Work Session of the Sandy Springs City Council was held on April 19, 2022 at 6:00 PM, Mayor Rusty Paul presiding.

A. 2022-94 Veterans Memorial Park Overview and Pedestrian Bridge Concepts

Gateway Fountain, Concept 1 (with fountains):

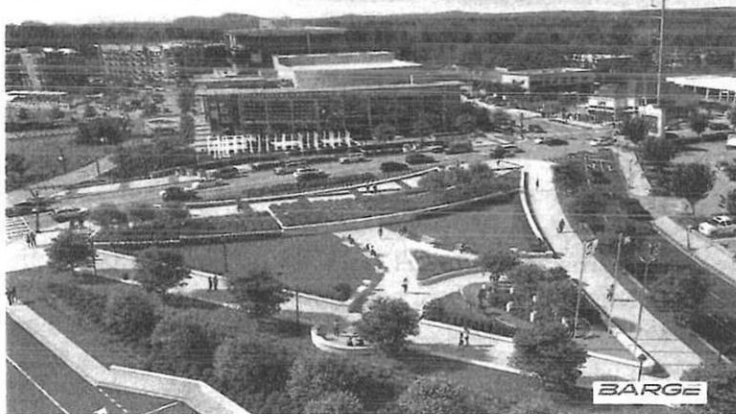
Mayor Rusty Paul stated one of the purposes of the fountains was also to mitigate the traffic noise, serving as white noise as visitors talk in the park. Will a flowerbed accomplish the same sound-deafening impact?

Councilmember John Paulson stated the fountain is needed to create balance, which was always the key. It is worth discussing if the City can accomplish the same outcome with a smaller fountain. As for the bridge, that is a lot of money. There should be discussions with the Georgia Department of Transportation and the Georgia Power Company to see what the obstacles are. Maybe the Georgia Department of Transportation would even like to build the bridge.

Councilmember Tibby DeJulio stated the mirror images of the fountains on both sides of Roswell Road will look dynamic. As for the bridge, if the Georgia Department of Transportation or the Georgia Power Company would like to build a bridge, then okay. It seems like a nice idea, but the City should not put money into it.

Councilmember Jody Reichel stated the flower beds are preferable to the fountains. There are many so bushes in front of the Performing Arts Center fountains that one cannot really see the fountain from Roswell Road. Also, there is no problem with the current traffic noise level in the area. The money would be better spent on building the pedestrian bridge, and hopefully, the Georgia Department of Transportation can help. This is for the safety of people and residents in Sandy Springs. And, the pedestrian bridge concept with just the elevator, and not the ramp walkway, is preferred because it is less real estate.

Councilmember Melissa Mular asked what is the cost difference between the flower beds and the fountains?

Councilmember Mular stated the idea of fountains is nice, but the cost is too high, so currently leaning towards no fountains. Also, the \$3.5M to \$5M estimated for the bridge is a lot, and the money could spent elsewhere and the city would get more out of it. There are low incidents of pedestrian accidents along Roswell Road. While there is a safety concern, there is also concern about spending the money in other areas.

Councilmember Andy Bauman stated while it is a nice idea, the cost of the fountain is in excess of 25% of the project. The City still wants to look for art in the park. Driving south on Roswell Road, passing City Hall, you cannot see the existing fountains. The flowers would look great, and if asked to choose one or the other, I would rather flower beds at this point. There are other components to the park and the rest of the budget to consider. This should be scaled back or eliminated. As for the bridge, it is a little early to know. There is more data needed. The visuals are nice, and there could be good opportunities with marquees on the side panel, but there is more information needed to make a decision.

Councilmember Paulson stated before the fountains are dismissed from the design, the City needs to do a little more homework, reviewing the possibility of paring back the cost while still conveying the image and the noise barriers. The current fountains are visible on Roswell Road.

Councilmember Bauman stated it is concerning that there are not many people at the current fountains. The fountains feel like a hidden feature. The space has not been activated, unlike the spaces by the swings and benches. My objection to the fountains in the park is the cost.

Mayor Paul directed Staff to collect more data regarding the modification of the fountain design, possibly reducing its size. Also, speak with the Georgia Department of Transportation and Georgia Power Company regarding the possibility of a pedestrian bridge.

John Fish, Barge Design Solutions, Inc., Vice President, stated that is correct. Similarly, when you step outside the Performing Arts Center, with the fountains running, the noise from the traffic is mitigated. There will be an increase in traffic sounds when sitting in the park without the fountain. The fountain may not need to be as big as depicted in the drawing to accomplish this. The other goal of the fountain was to create a symmetrical gateway element.

Barge Design Vice President Fish replied it is hard to say, but there could be a possible savings of \$1M to not build the fountain. Though, there will be some cost to achieve the needed plantings.
